Commissioning Report Executive Summary

United States Diplomacy Center Owner's Project Requirements

Design Phase Commissioning Plan

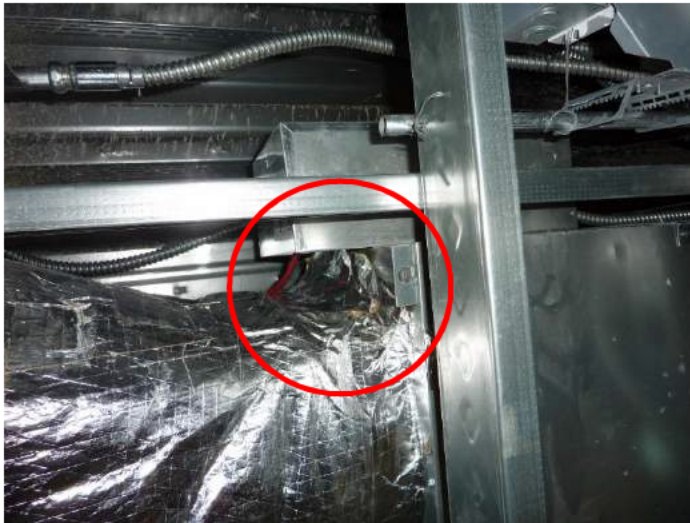
Vapor barrier not properly sealed.

Completely seal vapor barrier per manufacturer's requirements throughout project. Issue must be corrected prior to closing ceilings.

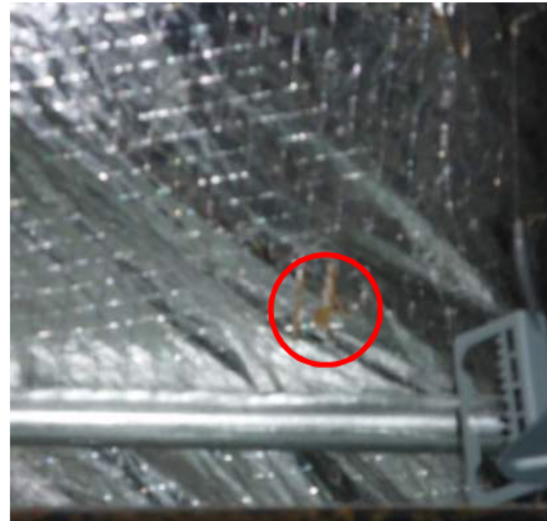
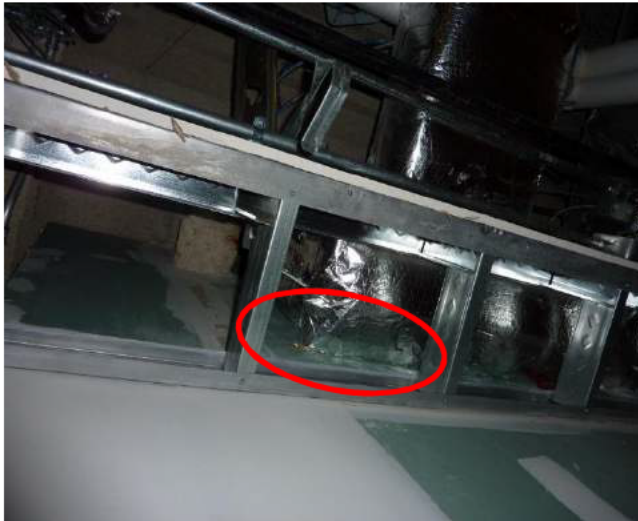
Above ceiling, issue is pervasive throughout project.

Vapor barrier not properly sealed.

Completely seal vapor barrier per manufacturers requirements throughout project. Issue must be corrected prior to closing ceilings.

Issue #33

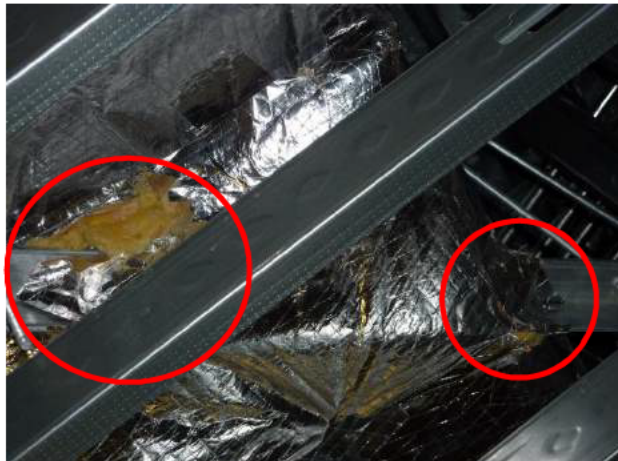
Above ceiling, issue is pervasive throughout project.

Support structure penetrating vapor barrier, penetrations not properly sealed.

Properly seal all vapor barrier penetrations per manufacturer's requirements throughout project. Issue must be corrected prior to closing ceilings.
